AMENDMENT NO. 2 FEBRUARY 2018
TO
IS 15804 : 2008 AUTOMOTIVE VEHICLES — WINDSCREEN WIPING AND
WASHING SYSTEM FOR M1 CATEGORY OF VEHICLES — REQUIREMENTS

FIG. 5 VISION AREA B

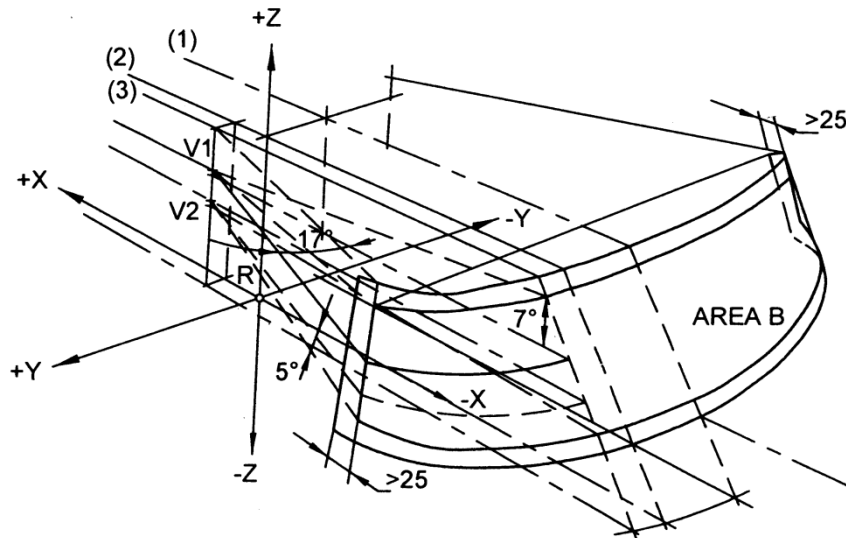
(Page 10, Annex B, Fig. 5) — Substitute the following figure for the existing figure:
